**Thursday, August 13, 2026
Monroe Planning Board Workshop Meeting**

TOWN OF MONROE
PLANNING BOARD
TECHNICAL REVIEW COMMENTS

PROJECT NAME: FBG HARRIMAN UPPER RETAIL LLC
PROJECT LOCATION: HARRIMAN COMMONS 2-1-34.2
PROJECT NUMBER: 10-11; 19-181
DATE: 11 AUGUST 2026
CONSULTANT: LANGAN
PLAN DATE: 23 DECEMBER 2019
DESCRIPTION: THE PROJECT IS PROPOSING THE CONVERSION OF RETAIL SPACE TO RESTAURANT SPACE WITH OUTDOOR DINING.

SITE LAYOUT AND GRADING PLAN

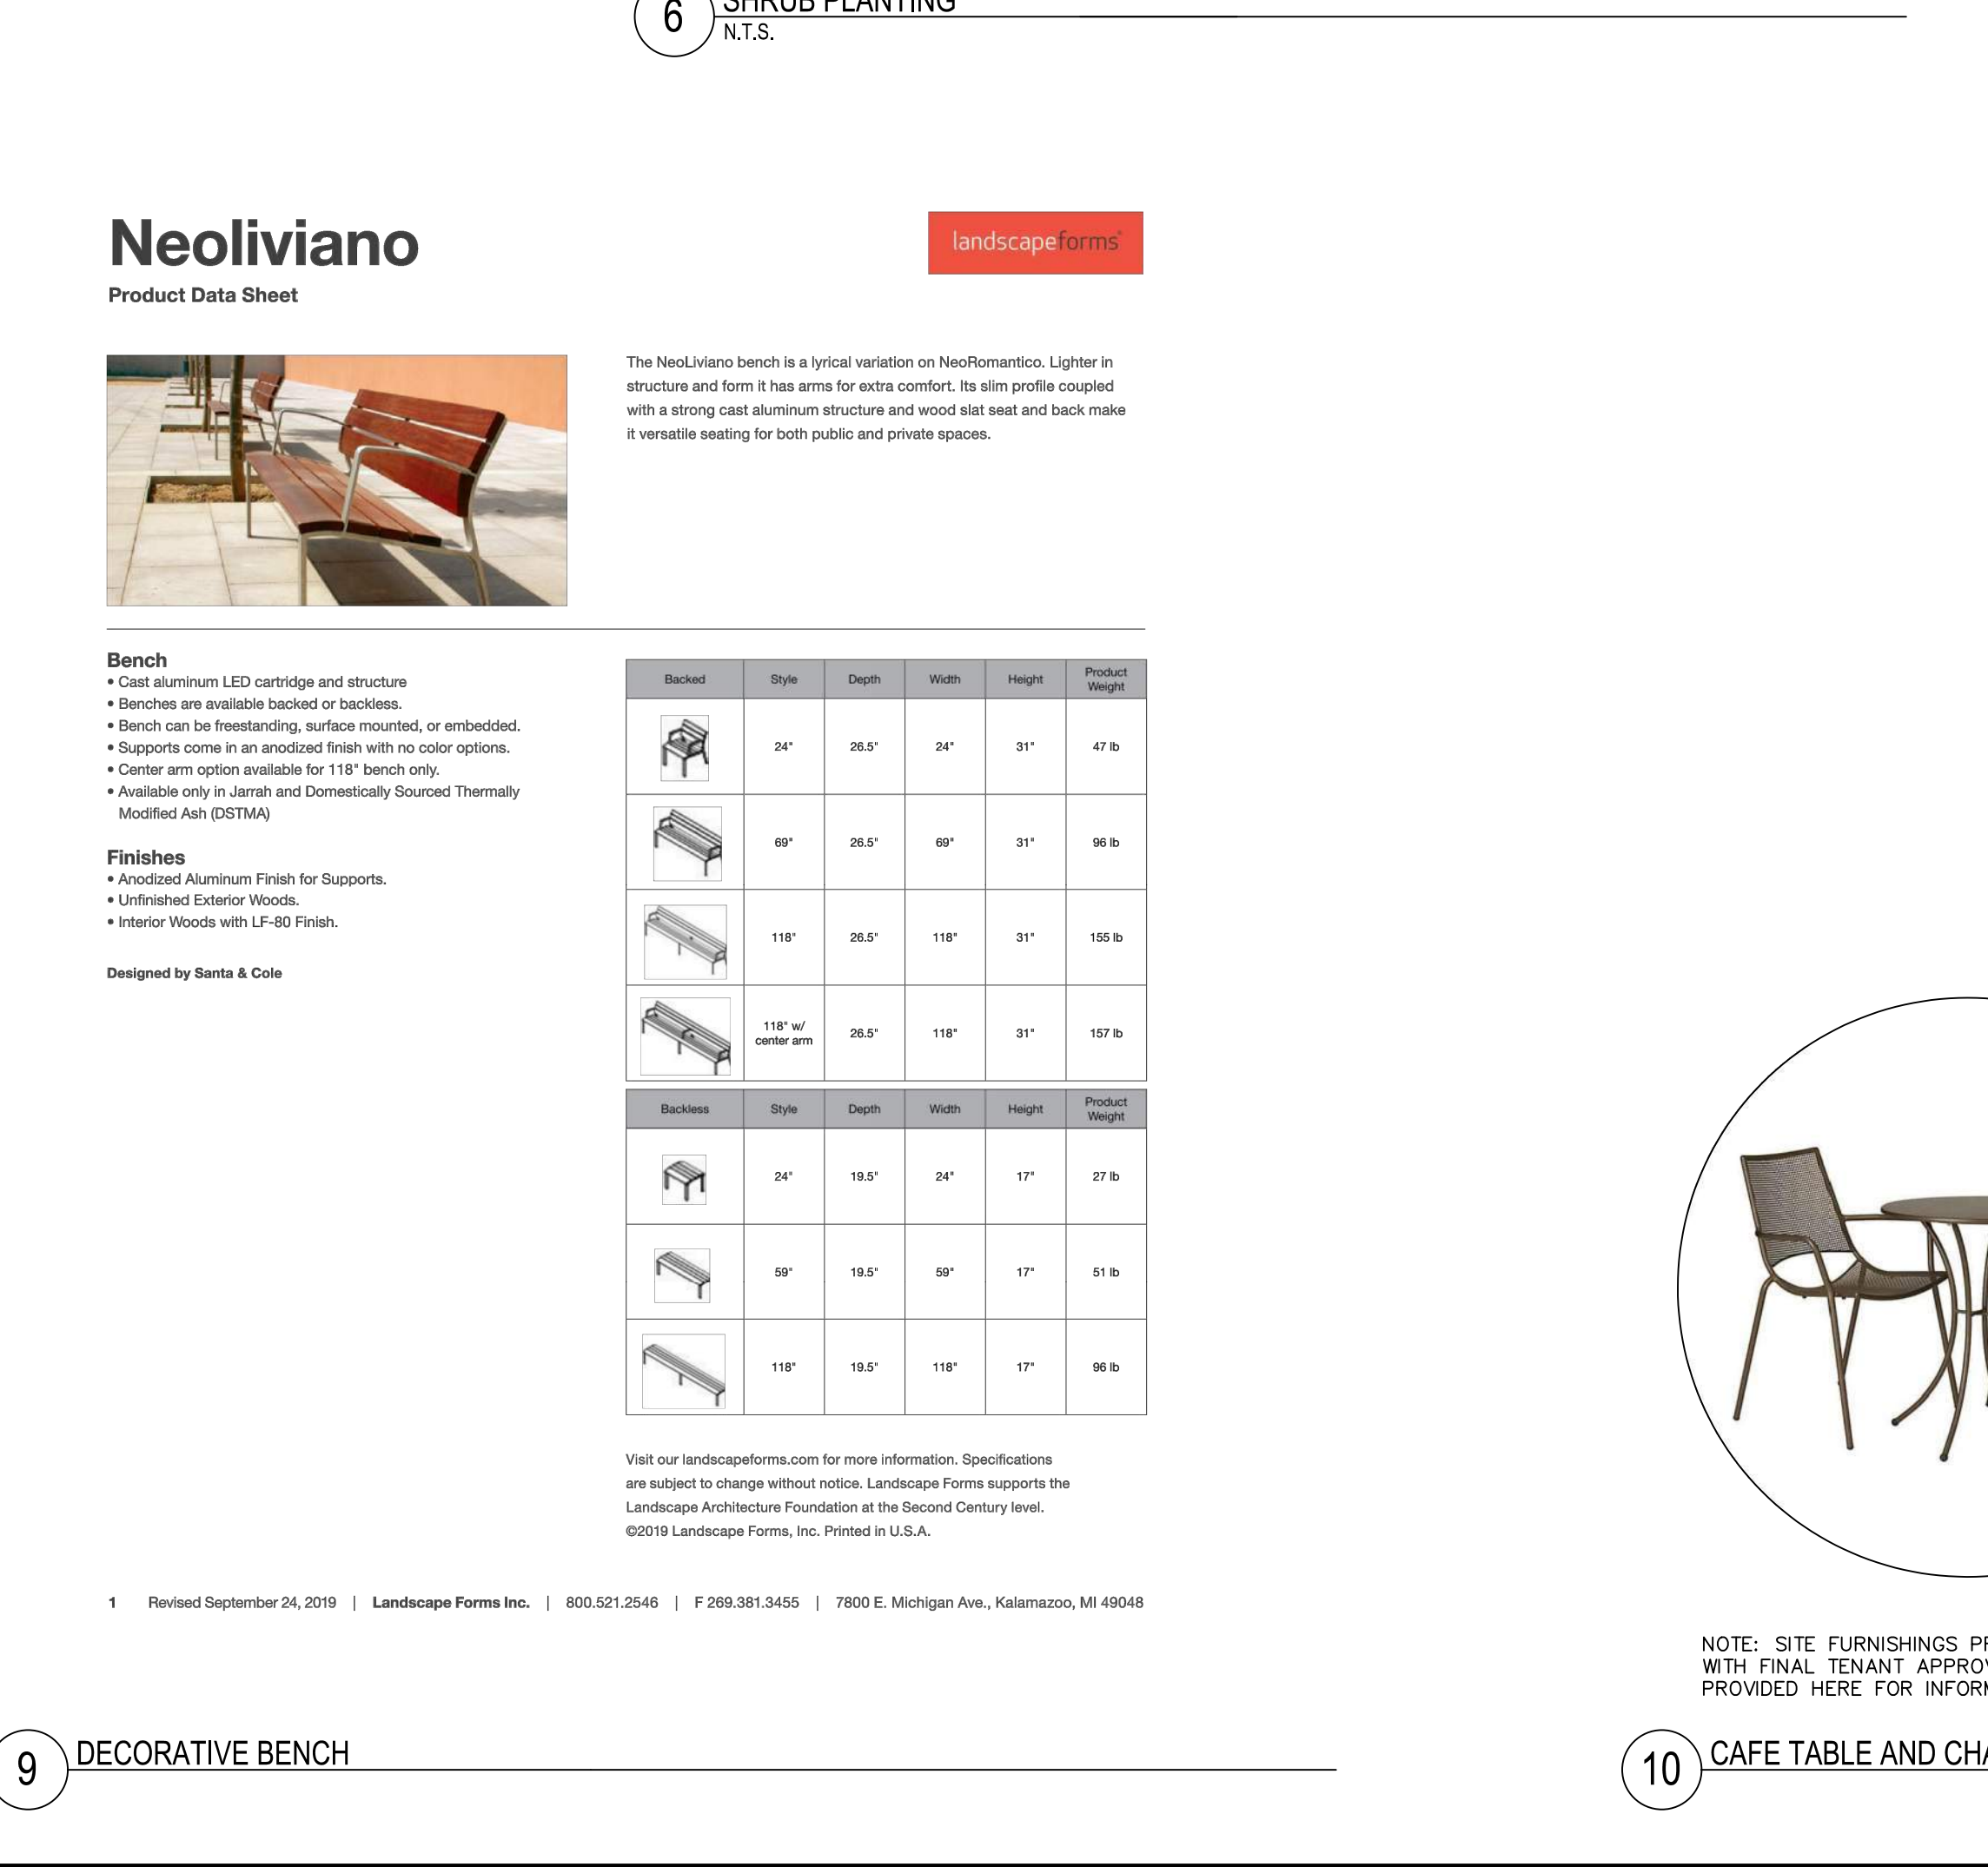
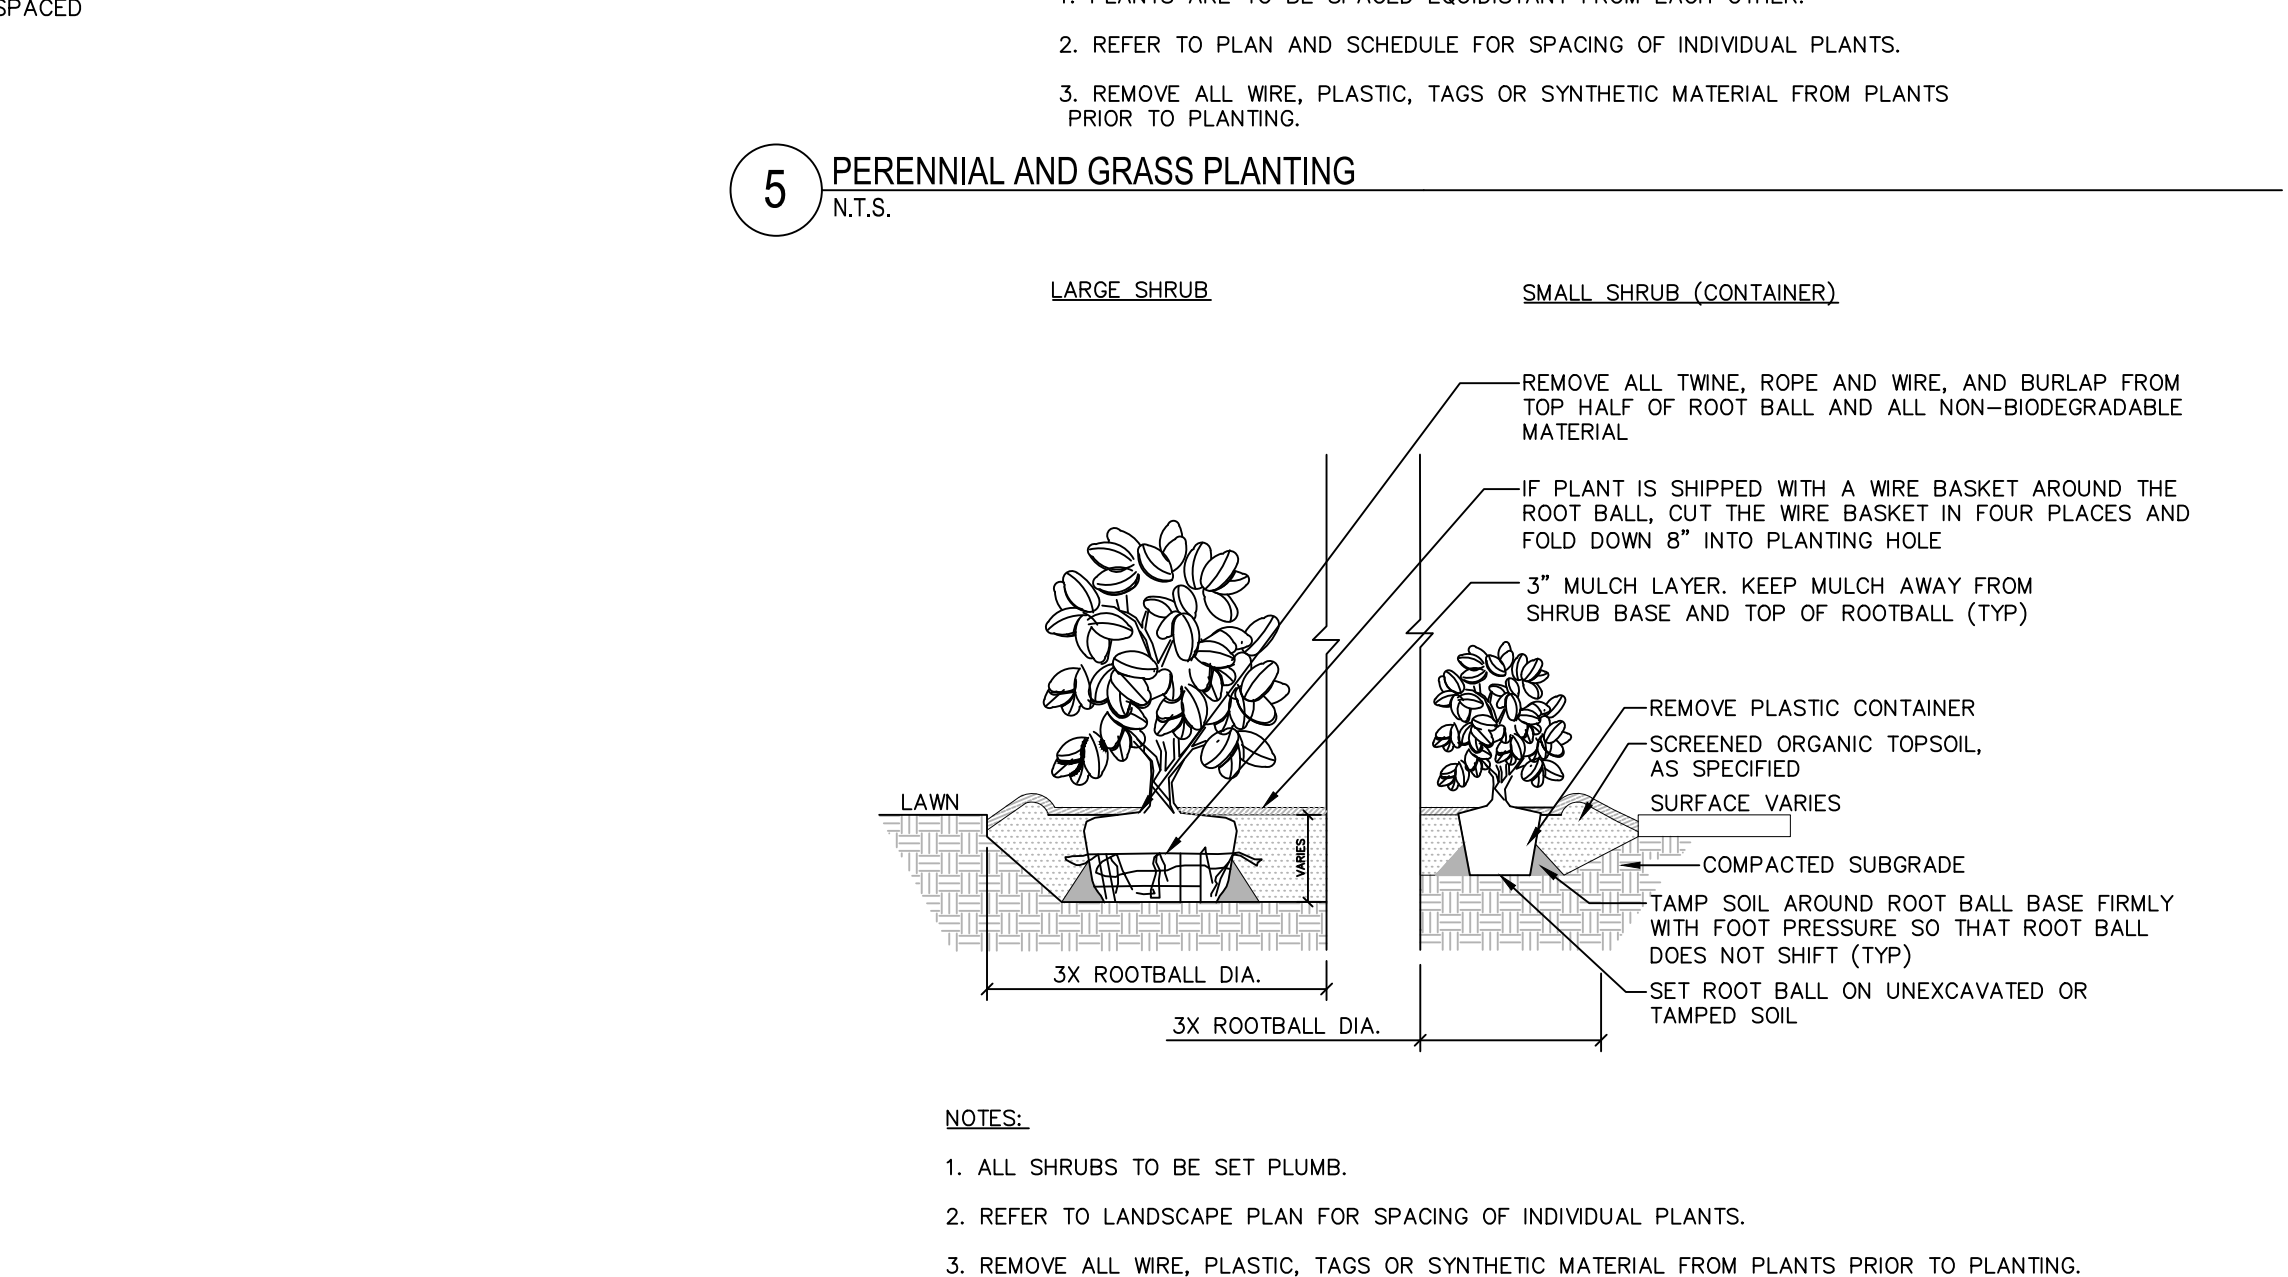
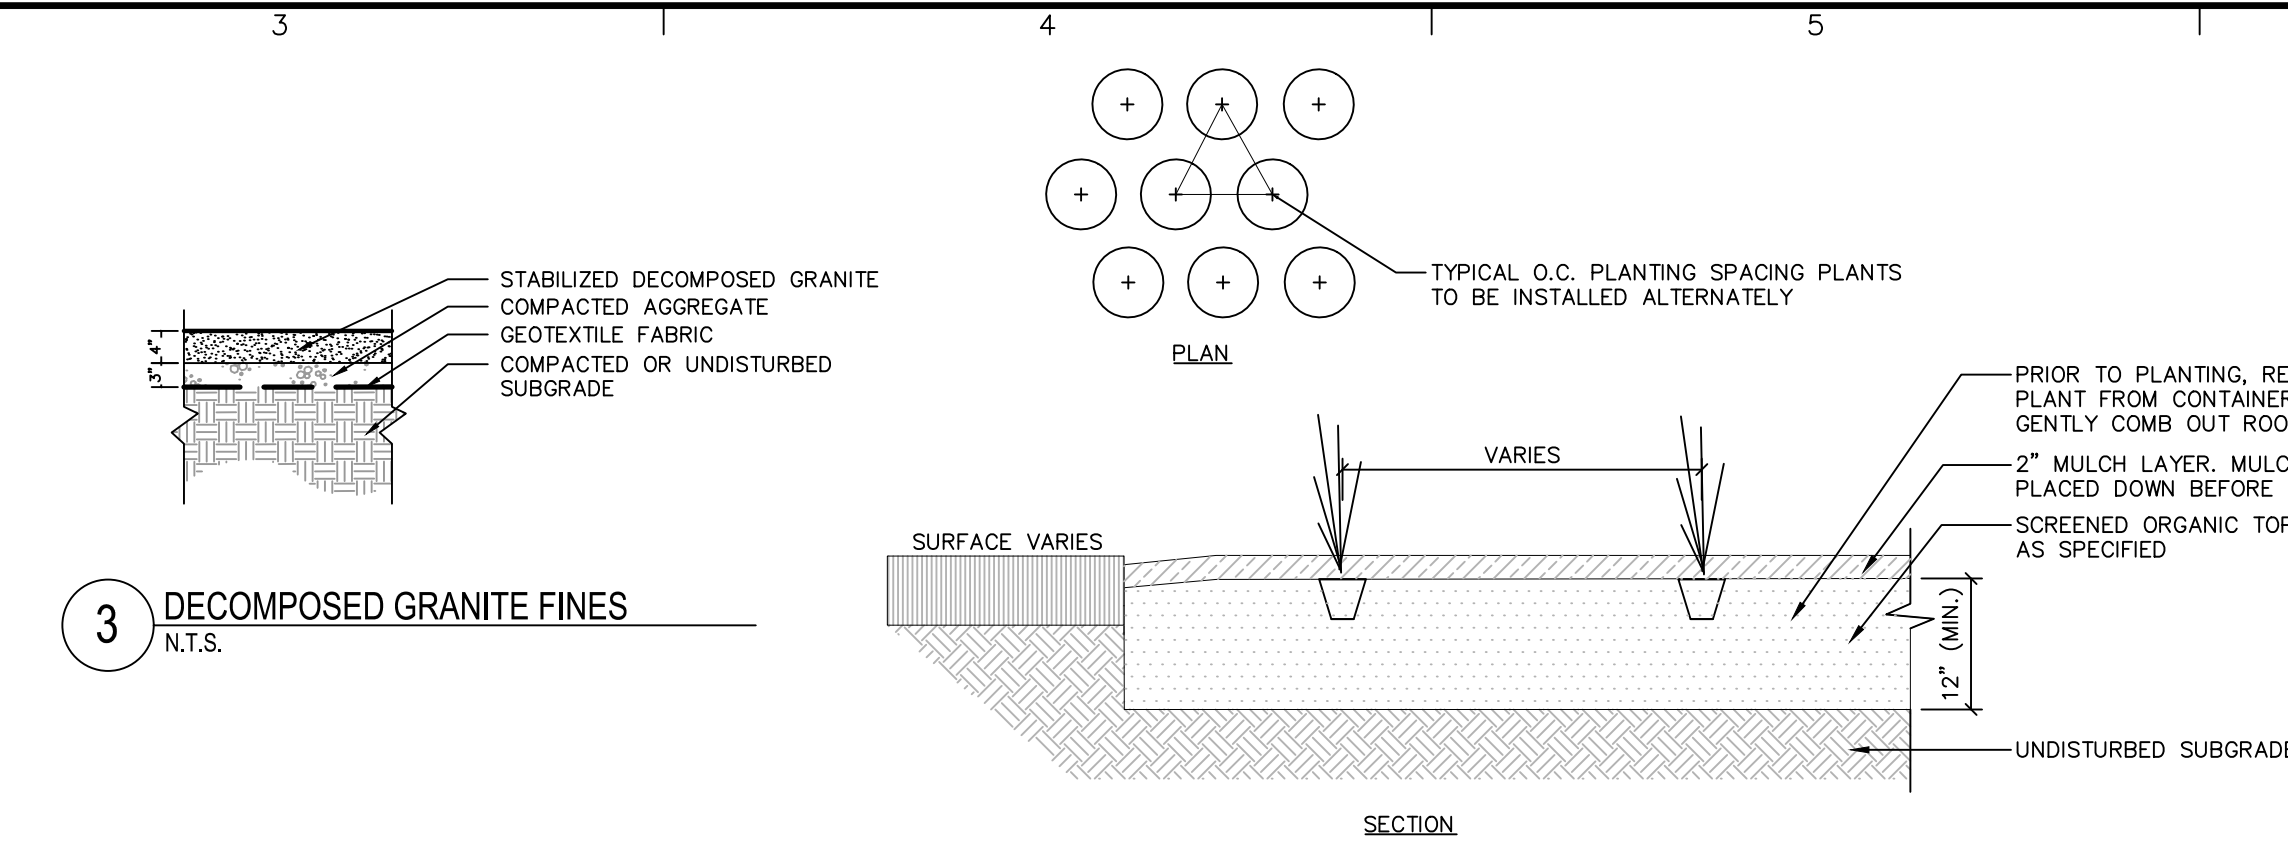
1. The site plan set submitted is from prior applications in 2019. The Design Professional should confirm that the plans accurately reflect the current site conditions.
2. The plans should clarify the location of the property boundary.
3. The Planning Board approval block should be updated to the latest version and placed in the lower right-hand corner of each plan sheet.
4. Verify that the proposed improvements do not impact the existing utility rights-of-way.
